LAKE HAVASU CITY, ARIZONA

ADDENDUM NO. 2

Lake Havasu City Police Department Rehabilitation Project PROJECT NO. 103006

November 9, 2023

Figure 1: Overall floor plan view

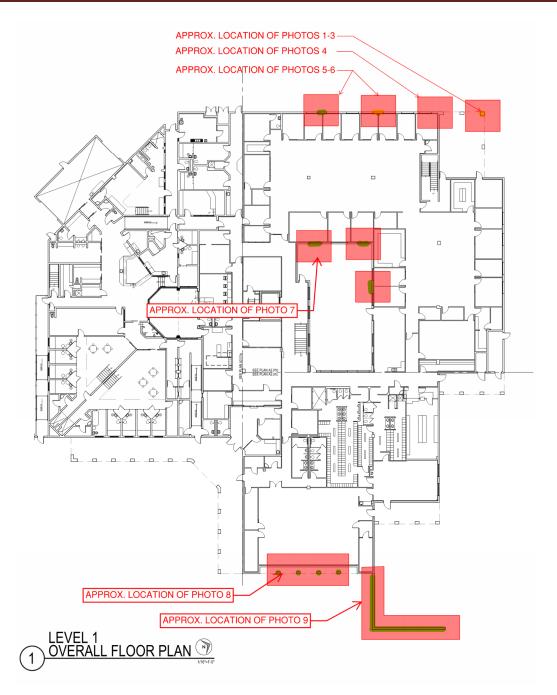
The structure listed above is constructed of Concrete Masonry Unit (CMU) blocks with concrete slabon-grade, and conventional spread footings and is estimated to have been constructed circa 1992. Figure 1 shows the locations highlighted in red on a plan view from the architect of the locations shown in the photos. Photos 1-3 show the deteriorated column, photos 4-6 show the wall, and photos 7-9 show other locations as shown from Figure 1.

Figure 2: Column Retrofit Structural Requirements

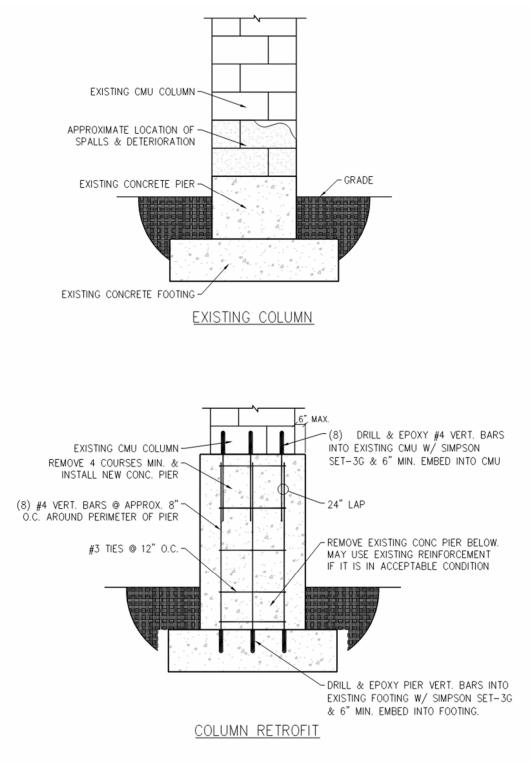
The structural retrofit for the columns from Photos 1-3 and 8 is shown in Figure 2 below. Where the exterior sidewalk is cracked in locations such as that in Photo 8, cut and remove the sidewalk square containing the cracked-off piece. Drill & epoxy #4x18" bars into the center of the existing concrete slab at 18-inches on center with Simpson Set-3G at new-to-existing slab locations.
